Origination Form
Proposed Revisions to a Standard Plans Index

Originator:	Turley, Joshua	Index Number:	400-091
Date:	5/15/2025	Sheet Number(s):	Sheet 2
E-mail:	Joshua.Turley@dot.state.fl.us	Index Title:	APPROACH SLABS (30 FT.) (RIGID PAVEMENT APPROACHES)

Sheet 2: Converted starred notes to numerical notes. Adjusted the coping embed requirements for the top of the retaining wall in SECTION THRU APPROACH SLAB AND RETAINING WALL.

NEW Notes Section Notes:

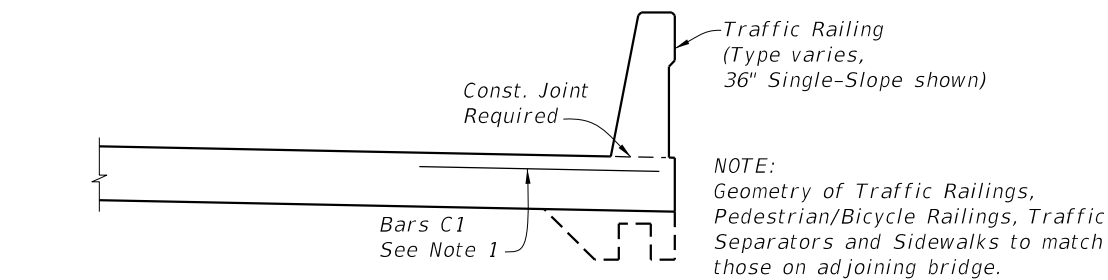
Moved to NEW Note 2

- 1.
- 2.
3. Expanded Polystyrene 1" min. top for MSE walls, 3" min. top for rigid retaining walls. 1/2" each side.

**SECTION THRU APPROACH SLAB
AND RETAINING WALL**

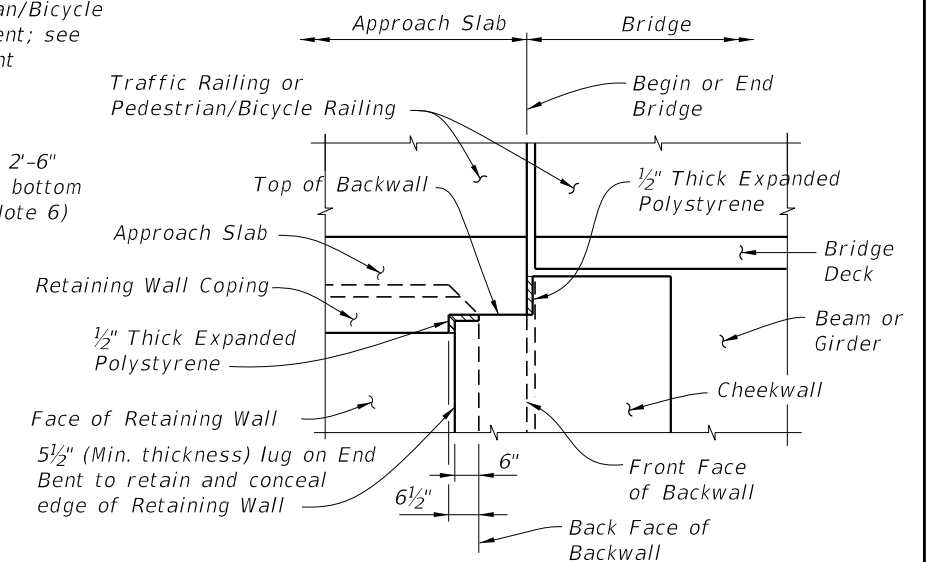
Contractors had trouble meeting top-of-wall elevations for MSE walls due to settlement issues. When predicted settlement didn't occur, walls were too high and required sawcutting. To address this, minimum thickness and embedment requirements for Expanded Polystyrene were relaxed, allowing better control over final wall elevations.

1. Bars C1 are required as shown when the 36" or 42" Single-Slope Traffic Railing, or the Traffic Railing/Noise Wall, are used at the edge of the Approach Slab.
2. Actual location & width vary depending on type of Retaining Wall used.
3. Expanded Polystyrene 1" min. top for MSE walls, 3" min. top for rigid retaining walls. 1/2" each side.
